## **SEWELL'S PLACE SUBDIVISION, RESUBDIVISION OF**

APPLICATION NUMBER 2 DATE April 7, 2011

REQUEST Subdivision

# DETAIL SITE PLAN

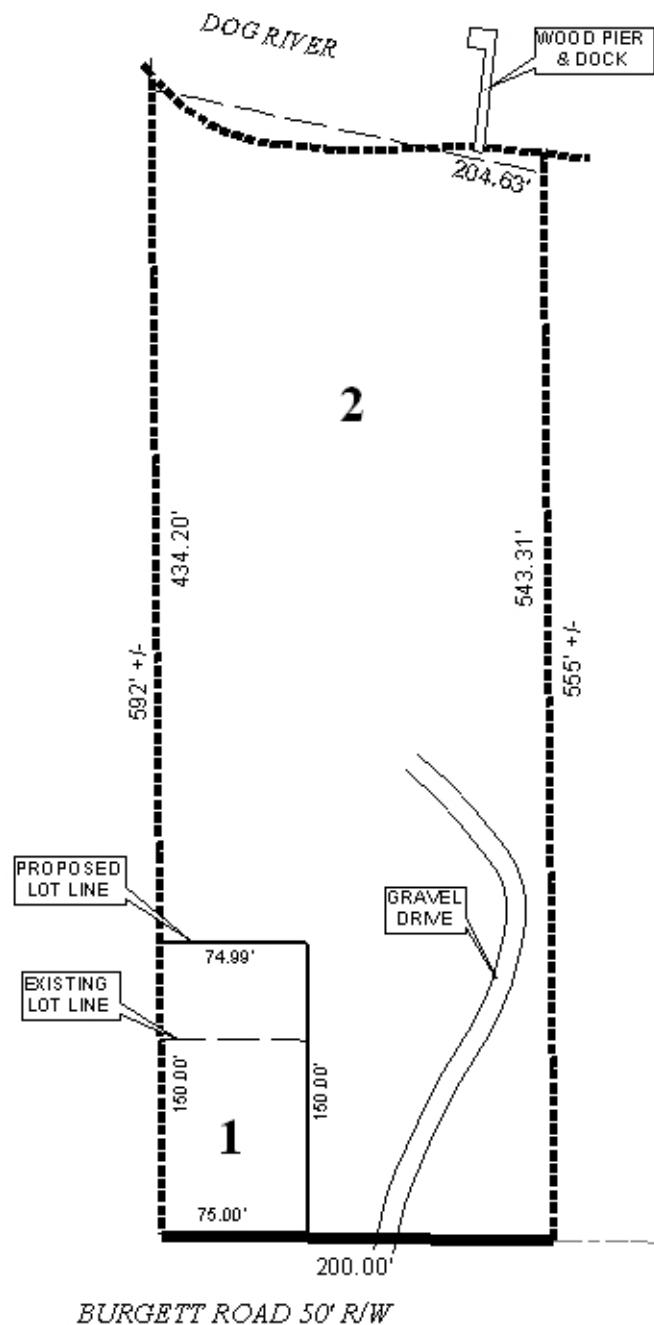
Each lot meets the minimum requirements of the Subdivision Regulations. However, the plat should be revised to label each lot with its size in both square feet and acres, or a table should be furnished on the final plat providing the same information. The plat should also be revised to illustrate the 25' minimum building setback line.

- 1) revision of the plat to label each lot with its size in acres and square feet, or the furnishing of a table on the final plat providing the same information;

- 2) revision of the plat to illustrate the 25' minimum building setback line on each lot;
- 3) placement of a note on the final plat stating that if NWI wetlands are present on the site, the approval of all applicable federal, state and local agencies would be required prior to the issuance of any permits or land disturbance activities;
